Attachment 1 - PLN21/0042 - 46 - 52 Smith Street Collingwood - Advertising S52 - Plans

To: Lara Fiscalini (Statutory Planning)
From: Christian Lundh (Urban Design)
Date: 16 April 2021
Site Address: 46-52 Smith Street, Collingwood
Application No: PLN21/0042
Description: Full demolition of 46 & 48 Smith Street and partial demolition of 50-52 Smith Street, construction of an 8-storey development, use of the land for restricted recreation facility (gymnasium), food and drink premises and office (permit required for gymnasium) and a reduction in the statutory car parking rate.

Urban Design Review

Pedestrian and Vehicular Entrances

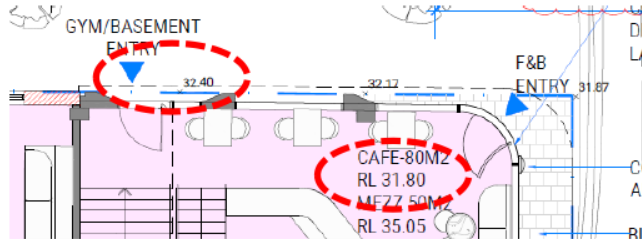
- Confirmation that the gym entrance design and be DDA compliant given the noted level difference between the existing footpath and proposed internal floor RL is 600mm, as highlighted in screenshot below.
 - If any steps, handrails, tactiles will be required, then these must be accommodated for within the subject sites boundary and must not protrude or be located within the public realm/footpath space.

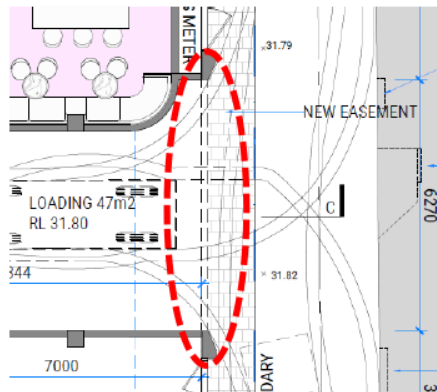
- Confirm that the location for the proposed roller door to the loading area from the laneway is in-line with the dash lines on the plan, no call out on plan noted. Concern if the roller door is setback from the building line that a space for loitering will be created.

- Confirm if there will be any façade / external lighting in the laneway to improve the safety and amenity in this space, noting that consideration regarding light-spill into adjacent properties must be considered.

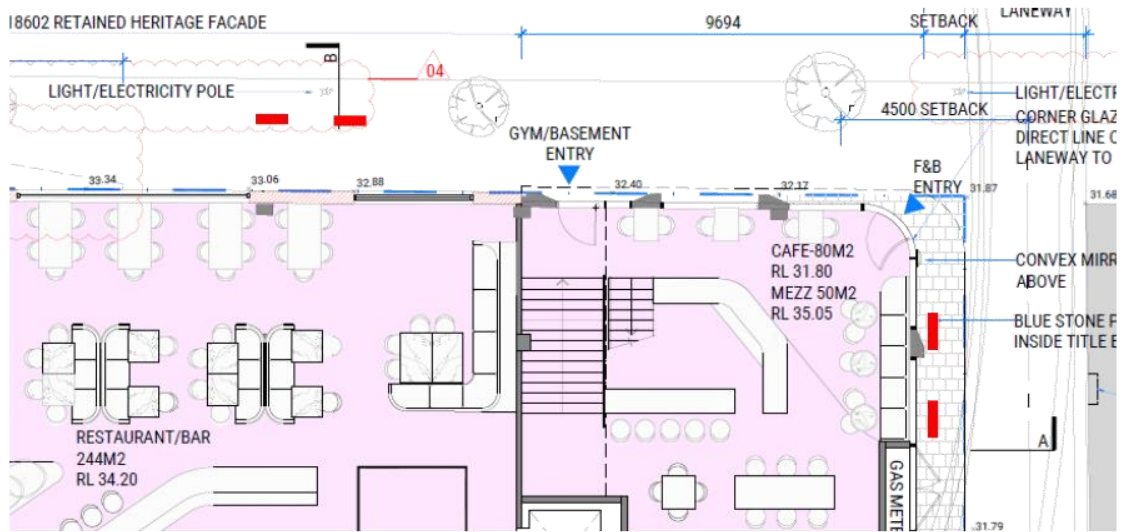
Distance between two bicycle boxes should be 0.6m to allow safe access to cyclist parked on the kerbside without a need to walk on the tree pit and/or the garden bed area.

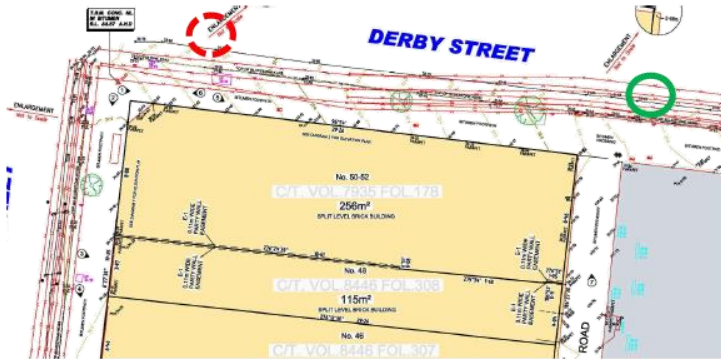
- The tree highlighted in street view below on the corner Derby Street and Smith Street, is missing from the survey including tree cut out. From desk top review of aerials, the tree appears to have been removed. It can be anticipated that Council will replace the tree like for like in the same position in due course.

- Show all existing trees and tree cut outs affected by the proposal, including cut out for 'missing' tree as noted in aforementioned comment, refer indicative mark-up below.

Figure 17: Excerpt from drawing A0950 (Section AA) indicating proportions of street width to building height ratio, including upper-level setbacks, to Smith Street. The approximate ration of with to height is 1:0.8 (height is 20% less than the width).

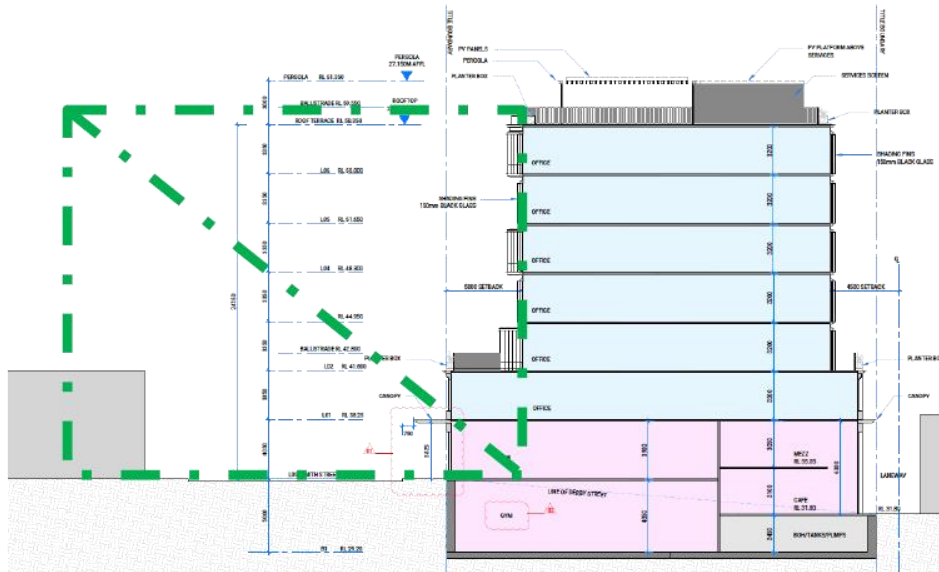
The height on Smith Street of 24.15m is commensurate with the 20m street width of Smith Street, and generates a width-to-height ratio (factoring in upper level setbacks) of 1:0.8, as shown in Figure 17 below (20m + 5m + 5m width; 24m height). I consider this proportional relationship to be acceptable.

Figure 22: Excerpt from North Elevation (drawing A0901) highlighting alignment of expressed canopy line relative to neighbouring building (above that building's windows, close to the cornice line).

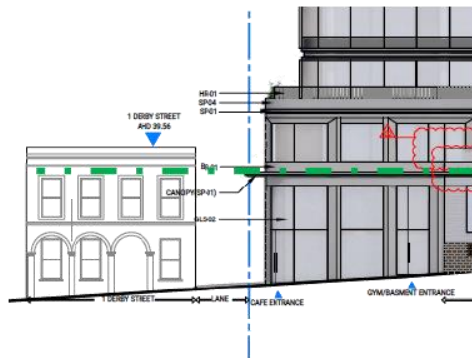
The expressed canopy line in the Derby Street facade, above Ground Floor, is slightly lower than the parapet and cornice of the neighbouring building, although there appears to be some discrepancy between this alignment in Elevation (drawing A0901) and photomontage (Urban Context Report, page 57), as shown below.

I consider the difference in height relative to the neighbouring building to be acceptable, because it is a result of the streetscape gradient, and other buildings in this streetscape step down the gradient, as shown at Figure 11 above.

Figure 1 – locations for additional visitor bicycle spaces

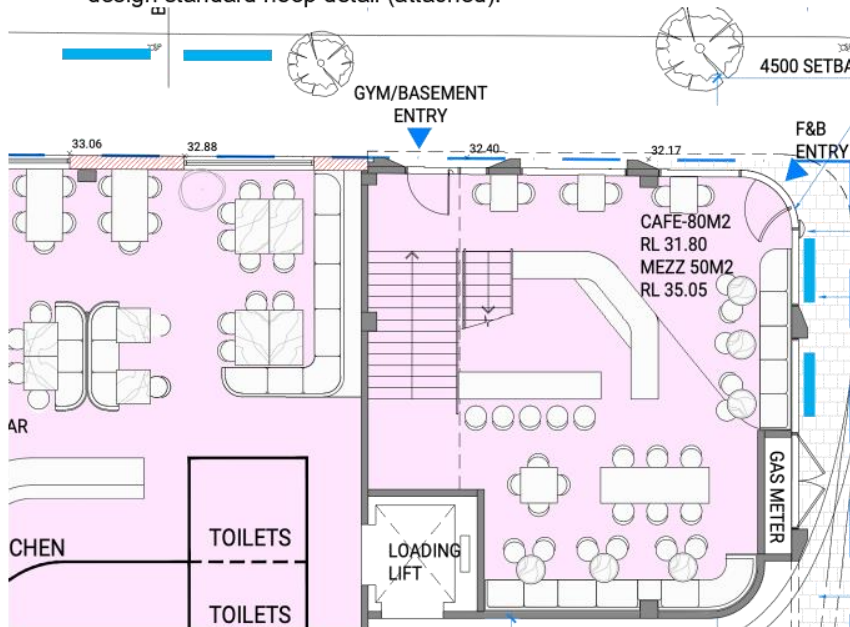
- 3 visitor spaces are provided within the gym and no publicly accessible visitor spaces are proposed. Council’s best-practice rate¹ recommends a total of 6 visitor spaces.
- It is recommended that additional visitor spaces are provided at the street level, including 2 hoops at the Derby Street footpath and 2 hoops at the easement, as per the locations marked up in blue on the screenshot below.
- All visitor spaces should be provided as a horizontal at-grade space and positioned in accordance with access and clearance requirements of AS2890.3 and Council’s urban design standard hoop detail (attached).
